Report to Planning and Environment Committee

Subject: 2783141 Ontario Inc. (c/o Zelinka Priamo Ltd.)
2060 Dundas Street
File Number: Z-9547, Ward 2
Public Participation Meeting

Date: August 13, 2024

Figure 3: Conceptual Site Plan – close up of area to be developed (original concept)

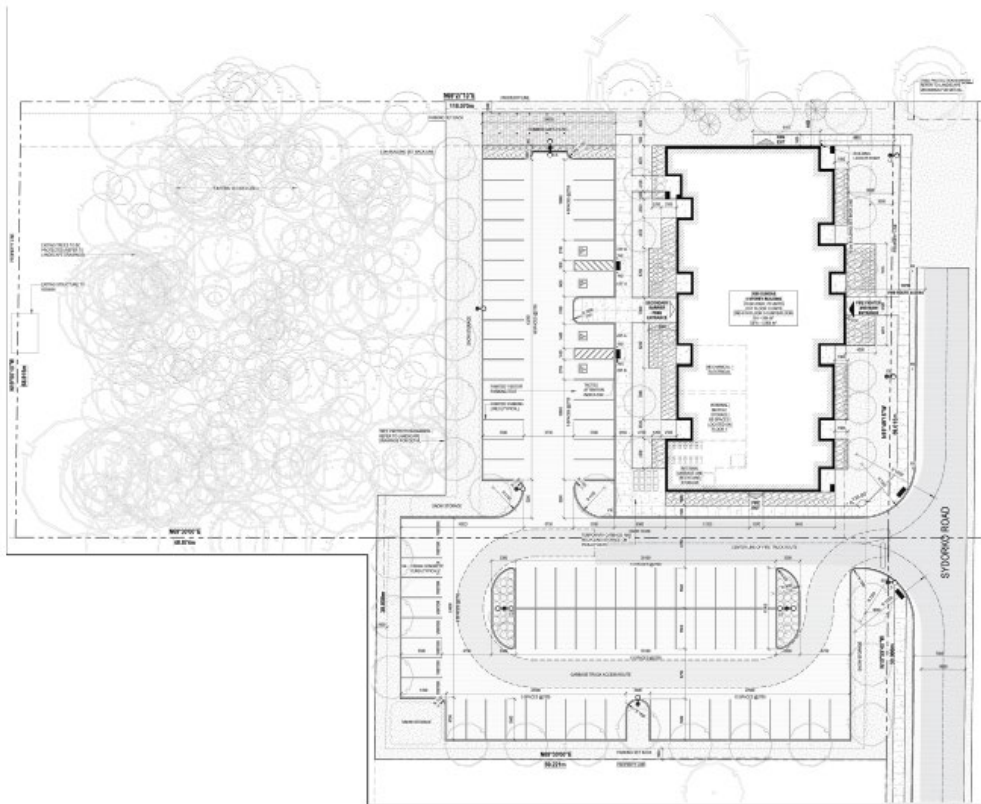
An ecological buffer was proposed to provide some physical separation between the woodland and the developed site; however, was insufficient and did not meet the

Figure 5: Revised conceptual site plan – close up of area to be developed

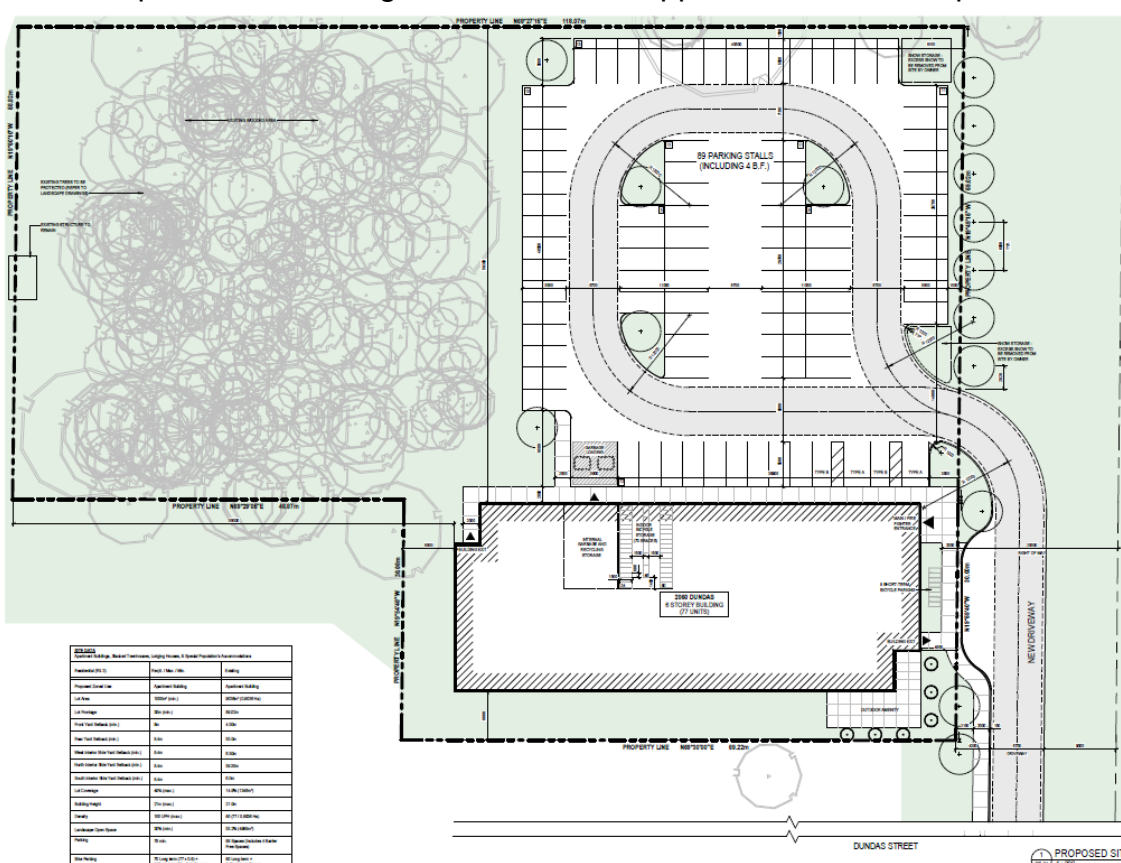
The applicant submitted a revised application on April 5, 2024 which shifted the proposed building south and moved the parking area to the north. Site access would continue to be provided from the City’s unopened right of way. The revised concept also reduced the number of units by one, for a total of 77 units. The rear portion of the subject lands continues to be maintained as a private woodland and wetland area. The ecological buffers, as proposed, still do not meet the Environmental Management Guidelines Table 5-2 requirements, and the revised development proposal continues to encroach into both the environmental features and required buffers.

The revised development concept does not fully address staff's concerns as the development continues to encroach into the natural features and buffers. In addition,

Staff are supportive, in principle, of the development of a 6-storey apartment building on the property if the building and parking areas are located outside of the environmental features and required buffers, and the features and buffers are zoned accordingly.

Figure 6: Key Field Findings Map showing feature delineations (MTE 2022)

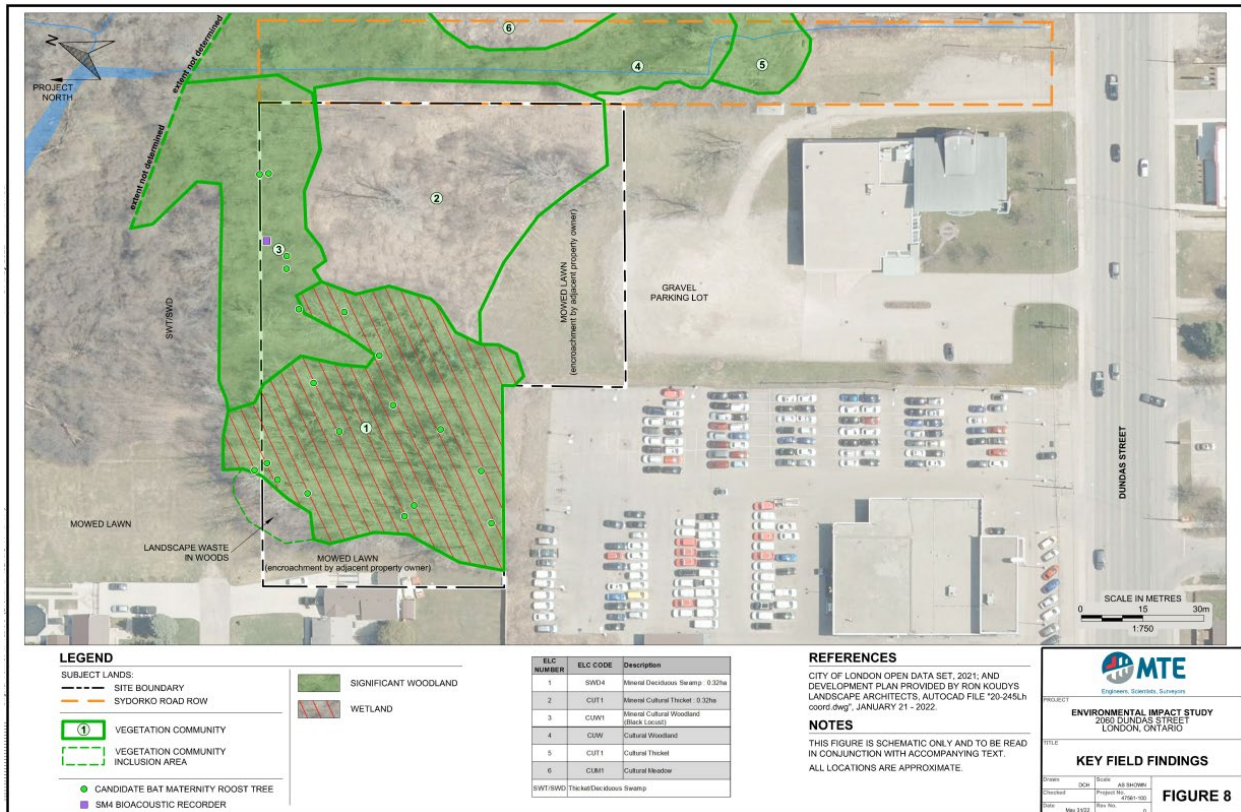
As part of the initial application submission, the applicant submitted an EIS prepared by MTE Consultants (August 2022). City Ecology staff raised significant concerns with the proposed development and the 2022 EIS, specifically with regards to delineation of the significant woodland and wetland features, lack of naturalized buffering from the features, and lack of suitable proposed compensation for features lost as a result of the proposed development. In response to these concerns, the applicant and City staff continued discussions to reach an agreement on the feature delineation, shown on Figure 6 below. Staff also agreed to the applicant's request to apply the 2007 EMGs to provide flexibility to assist in finding a design solution for the site. However, it should be noted that despite these agreements, the 2022 EIS was never accepted by City Ecology staff and the proposed development concept does not meet the buffers of the 2007 EMGs.

Figure 7: Key Field Findings Map showing feature delineations (MTE 2024)

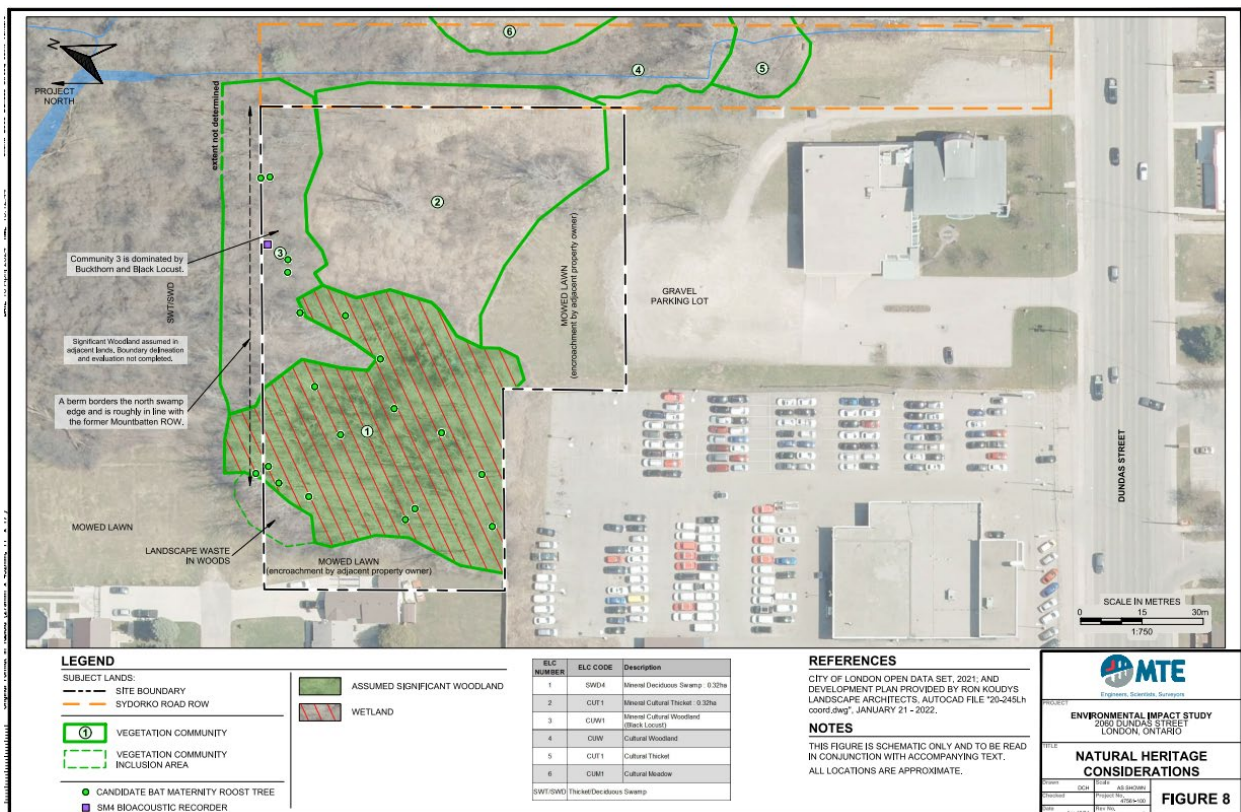
Following these discussions, the applicant submitted a revised EIS prepared by MTE (April 2024) in support of the revised development concept. The 2024 EIS contains significantly different feature delineations than the 2022 EIS, which had previously been agreed upon by staff and the applicant, and had the effect of removing the significant woodland classification from a large portion of the feature without adequate justification or suitable compensation for the loss of trees. This revision from the 2024 EIS is shown below in Figure 7 and is reflected through the removal of green shading, thereby no longer classifying these ecological sites as part of the significant woodland. The EIS has not been accepted by City Ecology staff and full comments are available in Appendix "B".

City staff through multiple meetings and email correspondence. The revised EIS (MTE, 2024) has removed ELC sites #3, 4 and 5 from the significant woodland boundary without adequate justification, as the feature has not physically changed between EIS submissions. Use the feature delineations consistent with Figure 8 in the previous EIS submission (MTE, 2022) that had been agreed to by City staff. The revised significant woodland delineation does not appear to be accurate.
